SUBJECT: PRAIRIE ISLAND NUCLEAR GENERATING PLANT, UNITS 1 AND 2 – STAFF ASSESSMENT OF RESPONSE TO 10 CFR 50.54(f) INFORMATION REQUEST – FLOOD-CAUSING MECHANISM REEVALUATION (CAC NOS. MF7710 AND MF7711)

STAFF ASSESSMENT BY THE OFFICE OF NUCLEAR REACTOR REGULATION

RELATED TO FLOODING HAZARD REEVALUATION REPORT

PRAIRIE ISLAND NUCLEAR GENERATING STATION, UNITS 1 AND 2

Figure 3.2-2. All-Season PMP Hyetograph Used in the LIP Analysis for the Prairie Island Nuclear Power Plant Site. (Xcel Energy, 2016a)

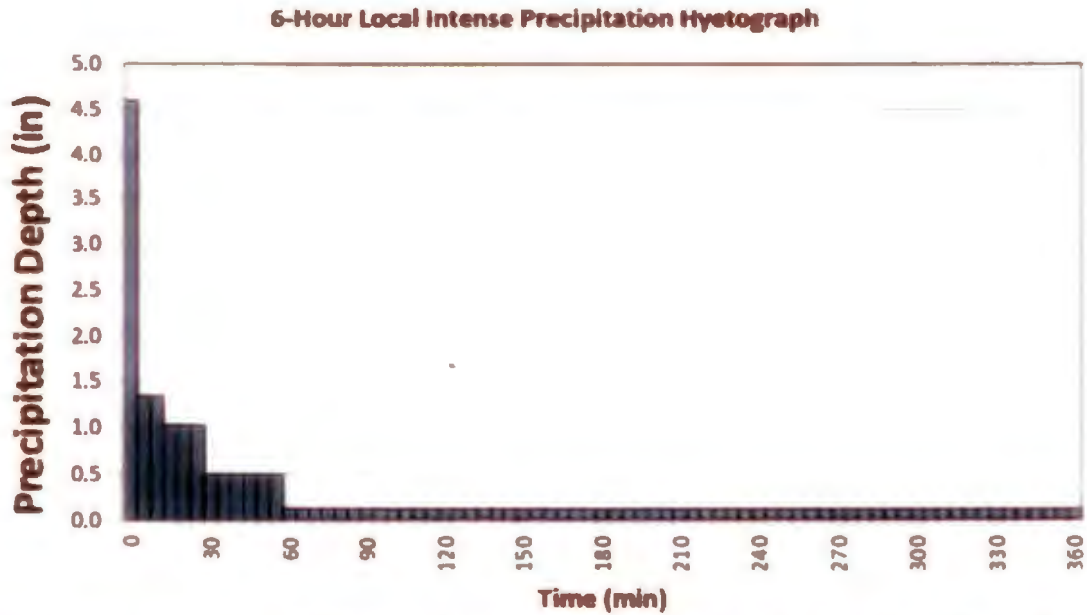
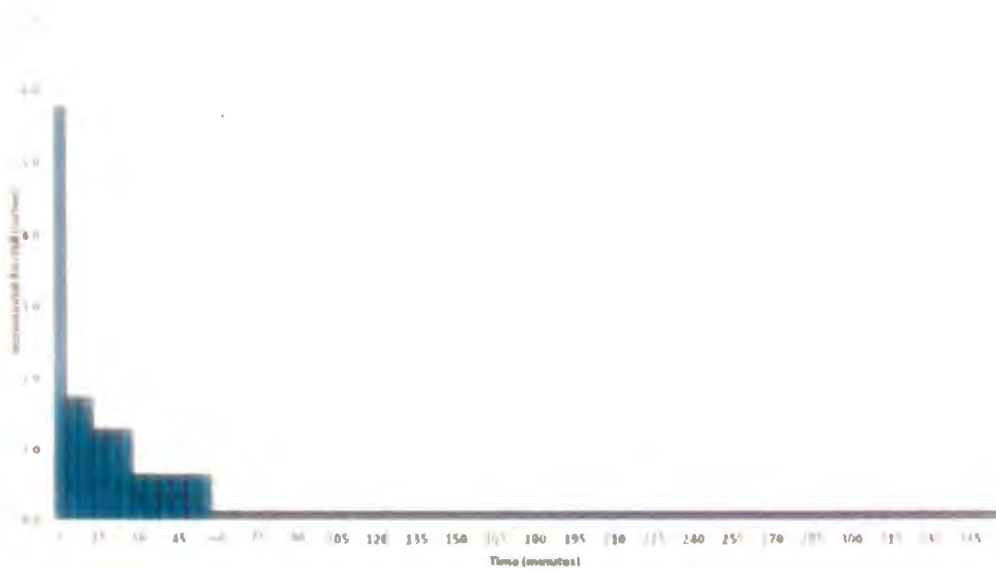
The NRC staff reviewed the licensee's use of an ssPMP by examining the sensitivity of the WSE estimate based on the use of an HMR value. In connection with that review, the NRC staff

found that the HMR-51/HMR-52 values for the Prairie Island site (Figure 3.2-2 of this assessment) were approximately equivalent to the precipitation values for the nearby Monticello site (Figure 3.2-3 of this assessment). In light of that similarity, as an analysis efficiency, the staff also used the HEC-HMS rainfall hyetographs from the Monticello site as input to the licensee's Prairie Island HEC-RAS computer model. The calculated WSEs based on either an ssPMP or an HMR-derived PMP value were subsequently found to be essentially the same at any safety-related structure location of interest within the Prairie Island powerblock. As a further PMP sensitivity test, the NRC staff increased the magnitude of the flow factor within HEC-RAS model by a factor of two thereby adding additional conservatism to the LIP model and the resulting difference between the WSEs at any safety-related structure from either source was less than 0.1 ft based on rounding.

As a result of these efforts, the NRC staff concluded that the results of the ssPMP flooding scenario described by the licensee are reasonable.

Figure 3.2-3. All-Season PMP Hyetograph Used in the LIP Analysis for the Monticello Nuclear Power Plant Site. (Xcel Energy, 2016b)

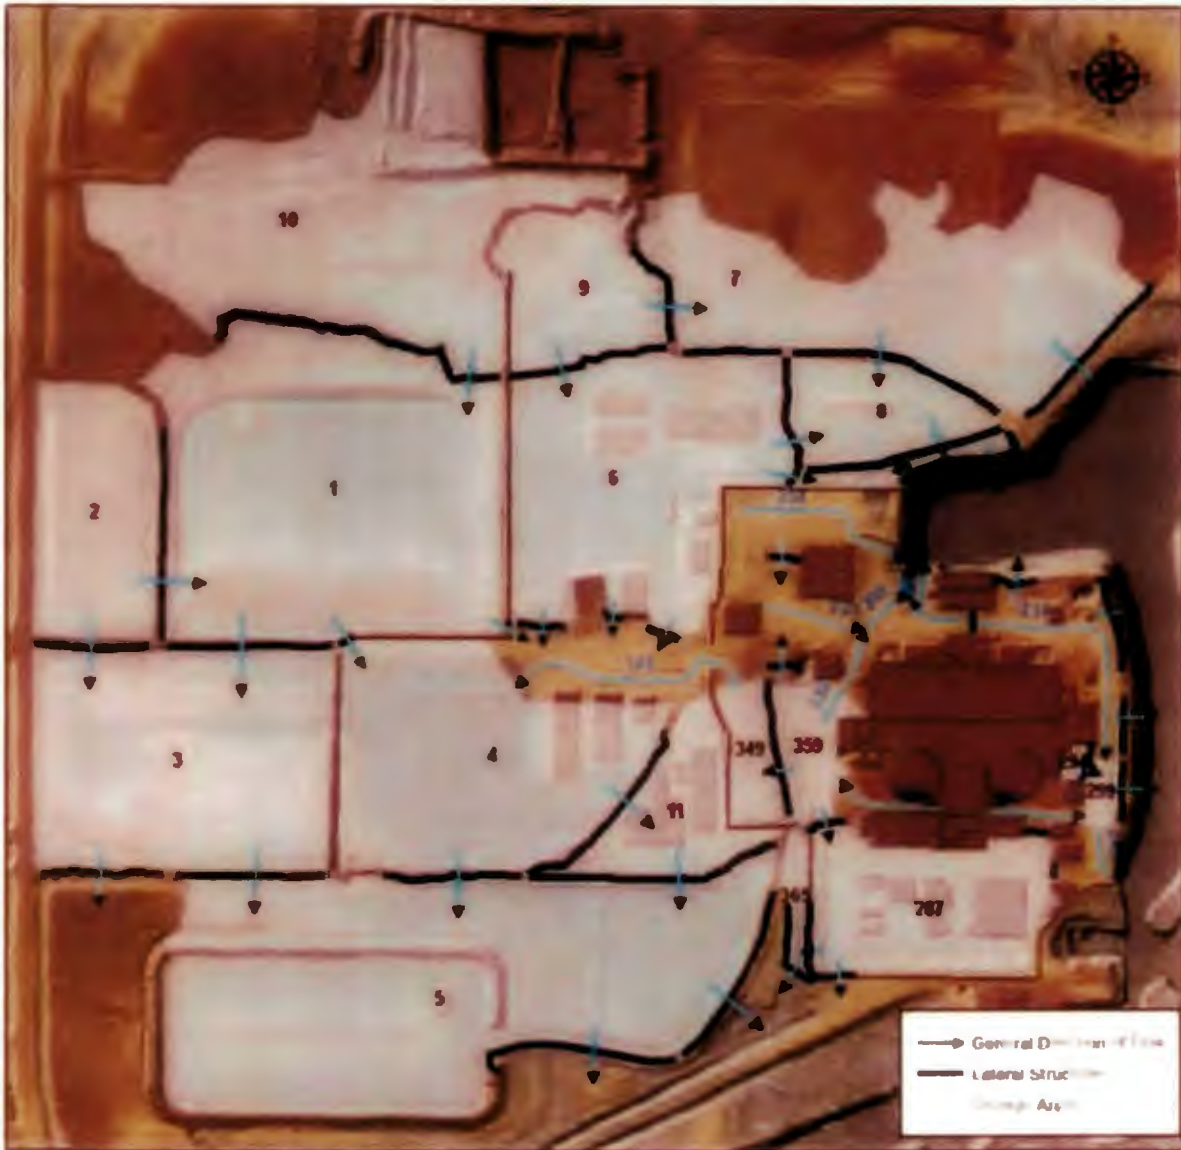
The physical features of the Prairie Island powerblock (e.g., permanent buildings, roadways, the VBS, etc.) incorporated into the licensee's LIP model were described in either the FHRR or the complementary LIP flood calculation packages (discussed during a 2016 audit with the licensee (NRC, 2017)). These documents also summarized key details concerning the LIP model. The licensee divided the HEC-HMS modeling domain into 32 sub-basins covering the power block area, switchyard, parking lots, and some topographically-higher, upstream contributing areas (Figure 3.2-4 of this assessment). In the HEC-RAS model, the model domain covers all 32 sub-basins and was divided into 18 storage areas and 10 conveyance areas. The licensee noted that the decisions on how to define the respective sub-basins were based on an examination of ground elevation data obtained from a LiDAR topographic survey, the elevations of various security barriers within the controlled area, and other as-built structures at the site. The licensee noted that the roofs of permanent buildings and other key structures were elevated in the LIP model to ensure that roof drainage would shed onto adjacent ground surfaces in order to maximize flood-related WSE estimates; moreover, those rooftops provided no rainwater storage. As an additional conservatism, site drainage systems were also assumed to be blocked and non-functional allowing for additional rainwater accumulation. Small gaps in the VBS were also reported to have been ignored in the hydraulic analysis. Lastly, the licensee stated that infiltration by ground surface materials was conservatively not considered. The NRC staff reviewed the LIP model and found that the basins are appropriately delineated, and the model domain covers the entire reactor site.

Having defined the respective sub-basins, the licensee then used the HEC-HMS software to model overland flow within those domains. The U.S. Soil Conservation Service (SCS) unit hydrograph method (SCS, 1986) was used to transform the PMP estimate into a probable maximum flow hydrograph for each of the 32 sub-basins. As a downstream boundary condition in the HEC-RAS model, the licensee assigned a WSE of 689.4 ft NGVD29 corresponding to a 500-year flood on the Mississippi River for all channel reaches discharging into the river. The NRC staff identified and confirmed the locations of buildings and other structures present within the HEC-RAS modeling domain using available aerial imagery for the Prairie Island site. Buildings were modeled as obstructions that completely blocked the surface flow of water. The NRC staff also confirmed that the representation of those features with higher elevations would both promote surface flow away from and/or around those locations. Lastly, the NRC staff
